UNITED STATES
NUCLEAR REGULATORY COMMISSION
WASHINGTON, D.C. 20555-0001

SAFETY EVALUATION BY THE OFFICE OF NUCLEAR REACTOR REGULATION
RELATED TO AMENDMENT NO. 229 TO FACILITY OPERATING LICENSE NO. DPR-28
ENTERGY NUCLEAR VERMONT YANKEE, LLC
AND ENTERGY NUCLEAR OPERATIONS, INC.
VERMONT YANKEE NUCLEAR POWER STATION
DOCKET NO. 50-271

Figure 2.8.7-24
Comparison of TGBLA-6 and CASMO-4 Coolant Void Reactivity Coefficients

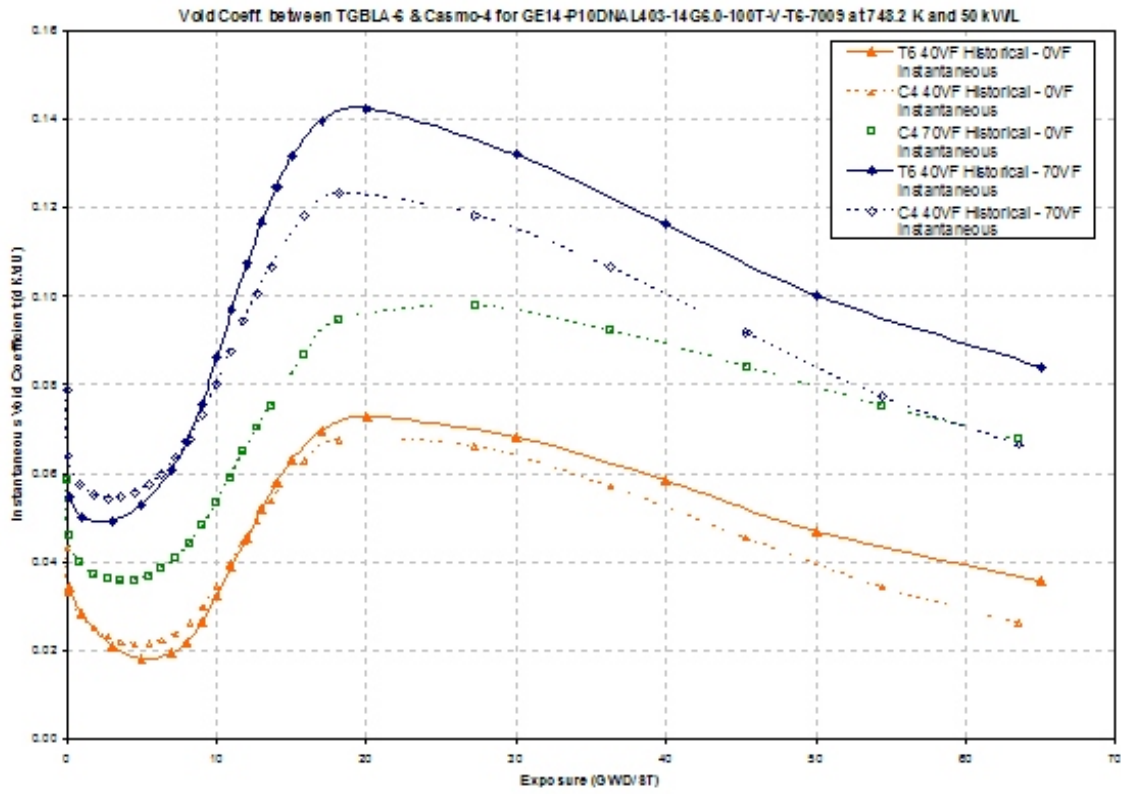
The void reactivity coefficient is an important parameter for predicting the transient response and stability of the reactor core. Comparisons of TGBLA-6 and CASMO-4 values of the void reactivity coefficient were compared in the RAI 66 response and are provided in Figure 2.8.7-24. The comparisons show that the agreement between the two codes is within the 15% assumed in the ODYN perturbation analysis. More significant is the large difference in the value of the void reactivity coefficient for the two different void histories used in the calculations (40% and 70%). The TGBLA/PANACEA neutronics methodology computes such instantaneous effects only for the 40% void history case. This assumption can lead to large errors in the evaluation of the void reactivity coefficient at high void fractions and high exposures. An evaluation of the impact of these errors was provided earlier.

Figure 2.8.7-25
Comparison of TBGLA-6 and CASMO-4 Pu-239 Composition for Lattice 6996

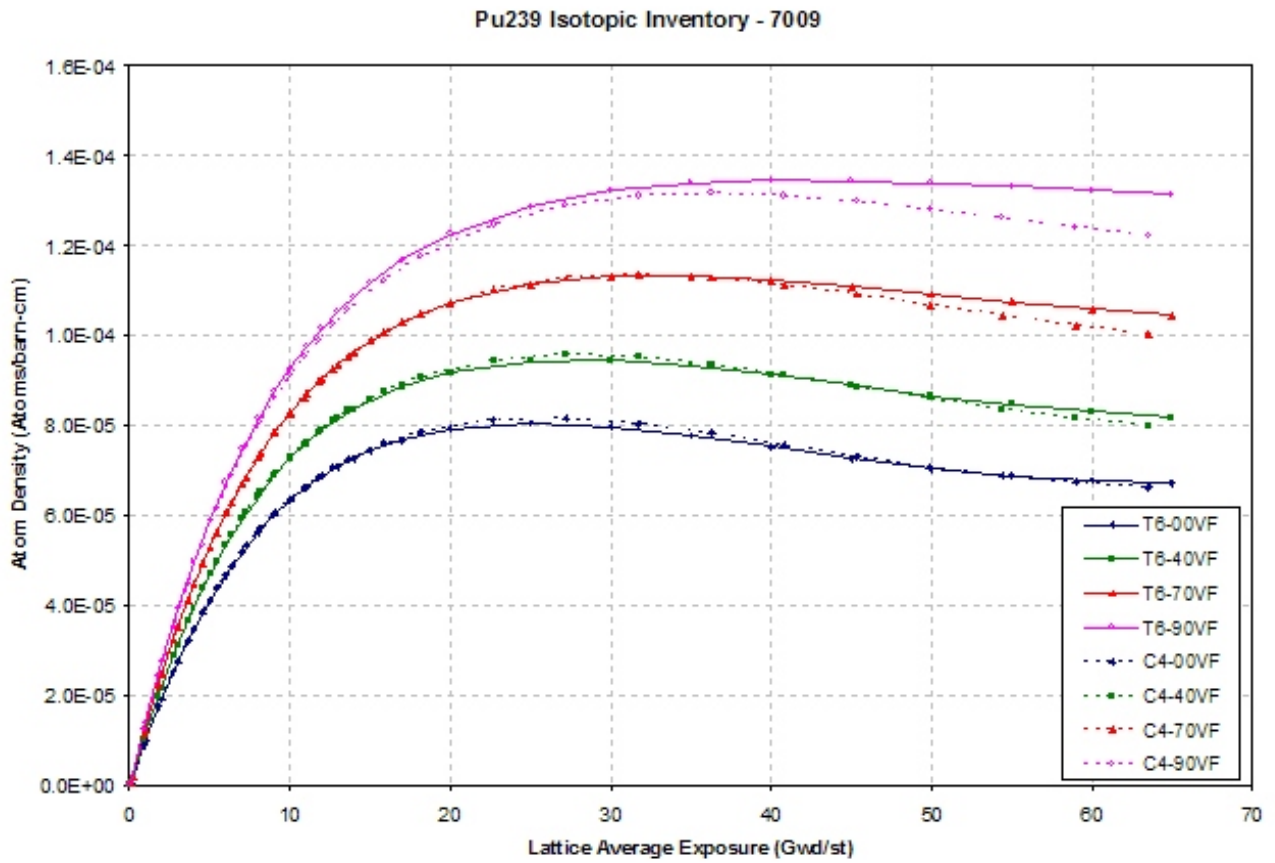
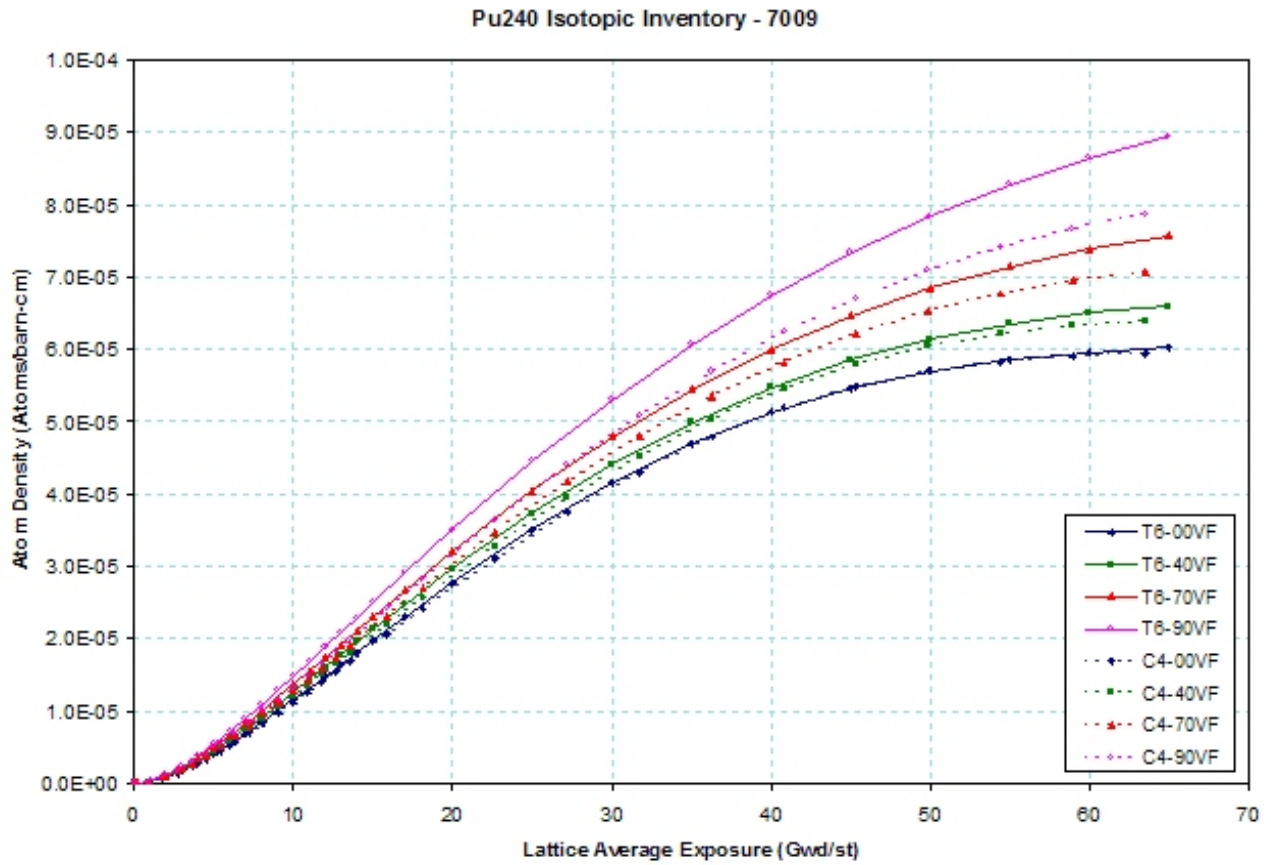
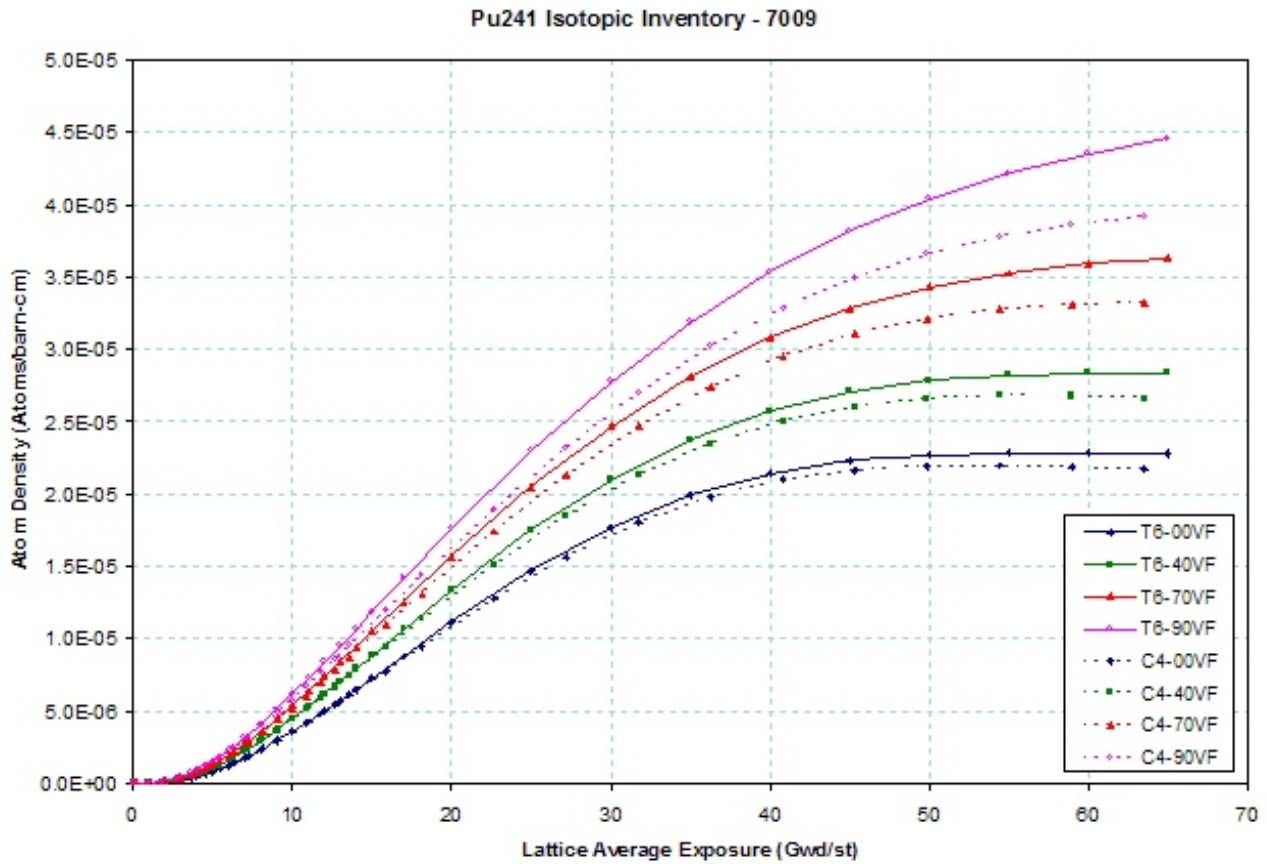
The plutonium compositions were compared between the two codes as an indication of the prediction of the neutron spectrum and as a further investigation of potential impacts on the void reactivity coefficient and SDM. The comparison of the Pu-239, Pu-240 and Pu-241 isotopic compositions (Figures 2.8.7-25 to 27) show very good agreement, particularly at the lower void fractions. Notably, Pu-239, the primary fissile plutonium species present, has very close agreement between the two codes.

Figure 2.8.7-28
Change in Pin Power Distribution Between 0% and 30% Bypass and Water Rod Voiding

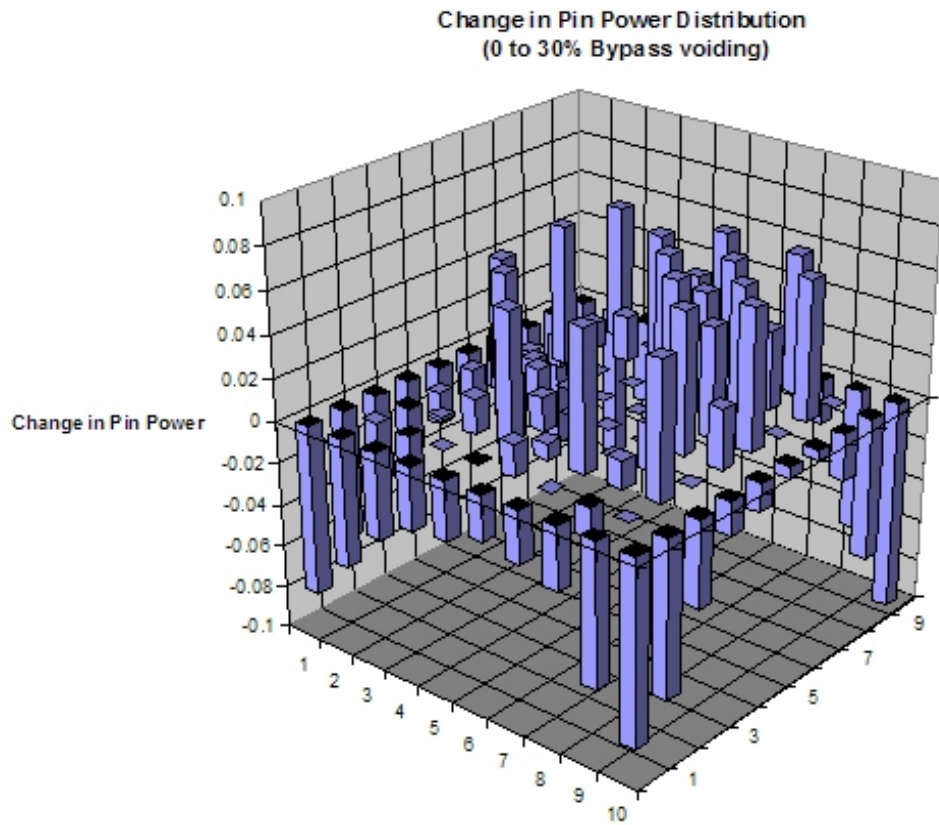
The results indicate that the power generation in the bundle is shifted away from the bypass region to the interior region of the bundle as voiding occurs. This is clearly demonstrated by plotting a difference of the power distribution between the 0% and 30% voiding cases, as is shown in Figure 2.8.7-28. The largest reduction in the pin power occurs in the corner pins, which have two faces adjacent to the bypass region. This results in a reduction of the power peaking factor since the peak pin is located near the bypass region. The reduction in the RMS of the pin power difference from the unity results presented in Table 2.8.7-3 show that the power profile becomes more uniform (“flatter”) as the bypass region voids (an RMS of zero would indicate a flat power profile, while a large value indicates a high-degree of peaking). The results also show that the relative power of the peak pin also decreases (the peak does remain in the same pin for all bypass void conditions). The reduction in the lattice K_{inf} value indicates
